Title	HESSI HVPS		
Size B	Document Number	HESSI 83	Rev 11
Date: Tuesday, August 10, 1999	Sheet 1 of 1

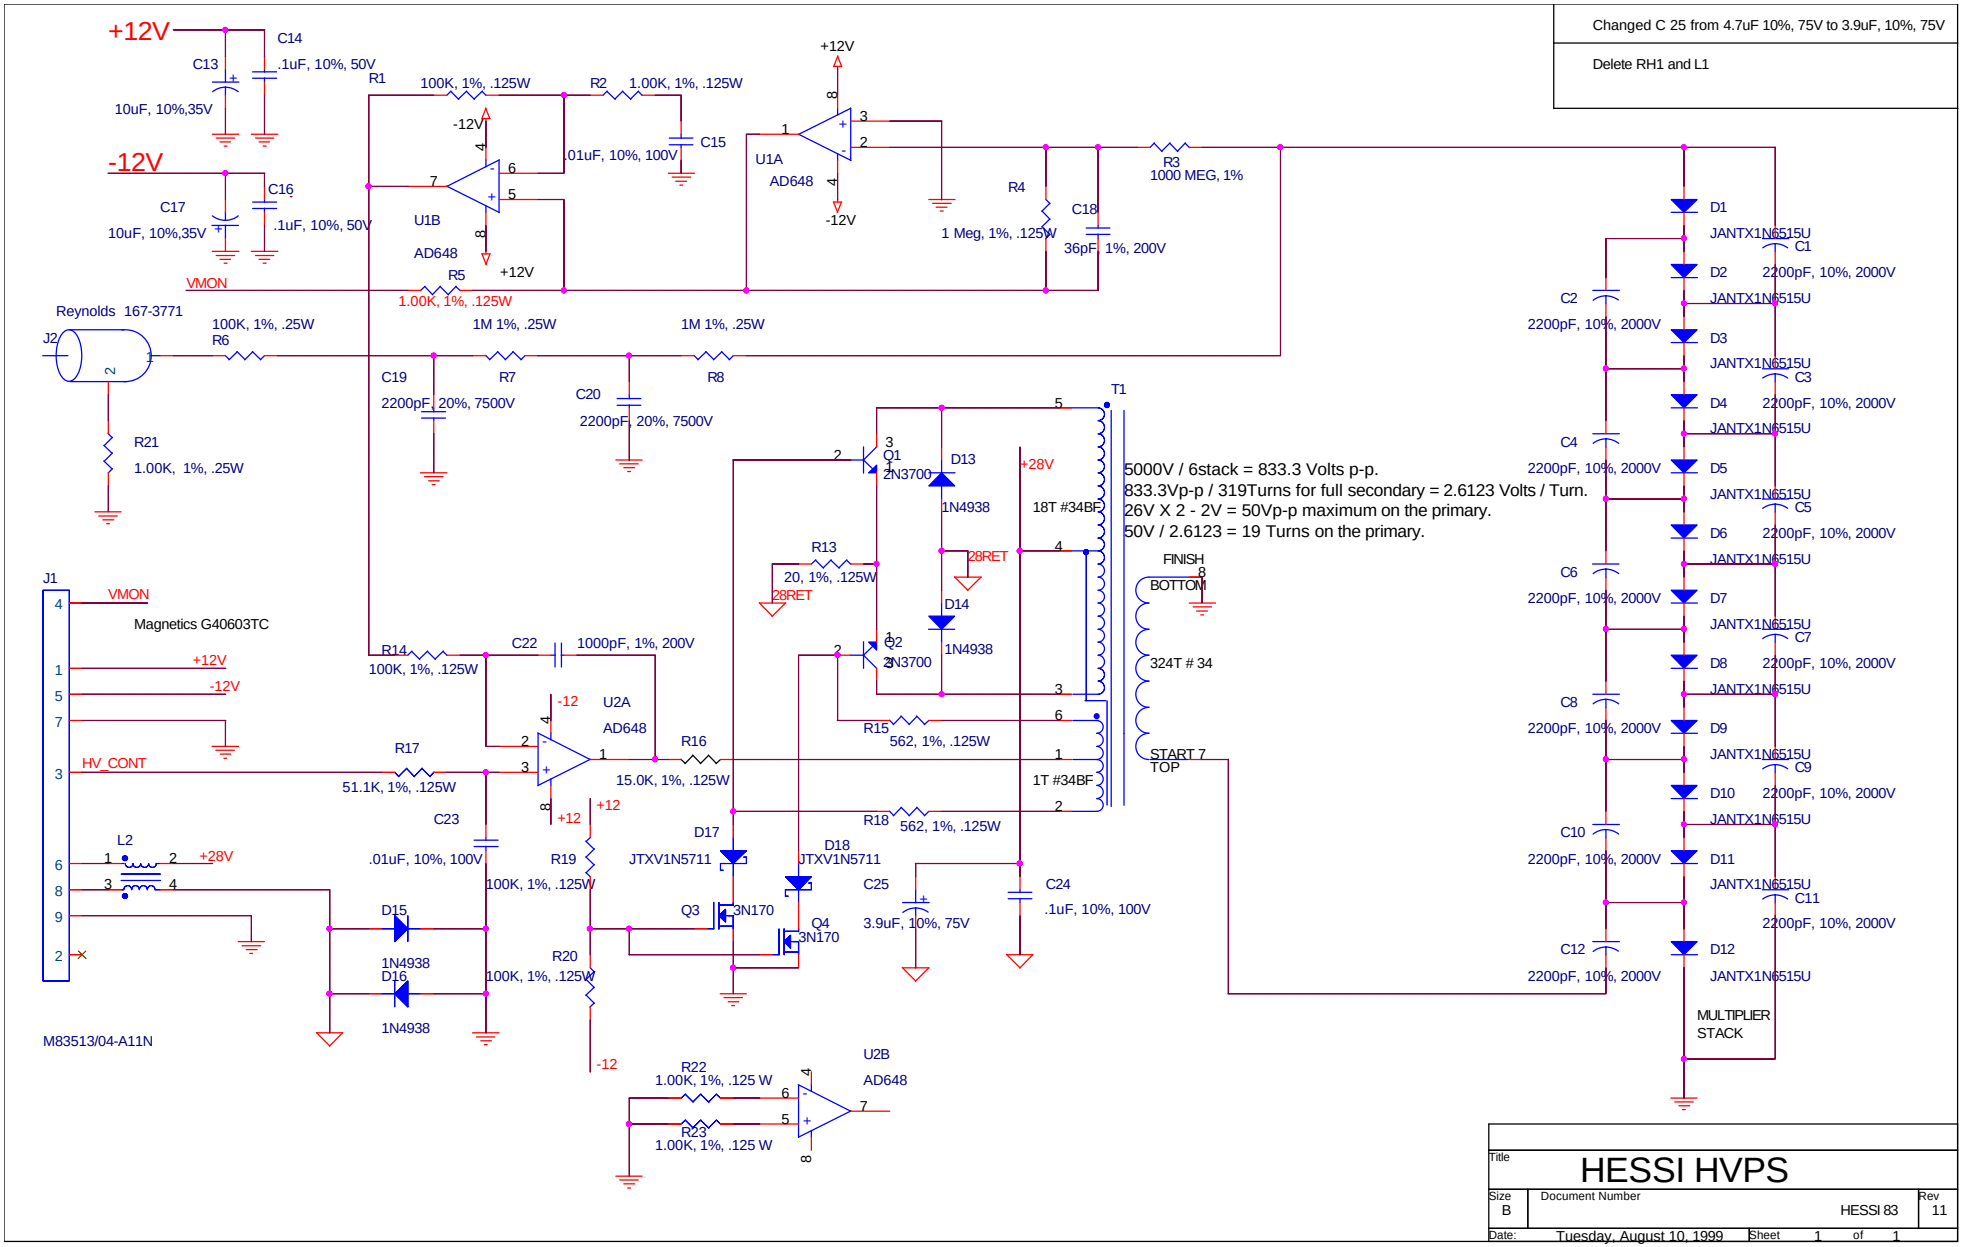
Changed C 25 from 4.7uF 10%, 75V to 3.9uF, 10%, 75V

Delete RH1 and L1
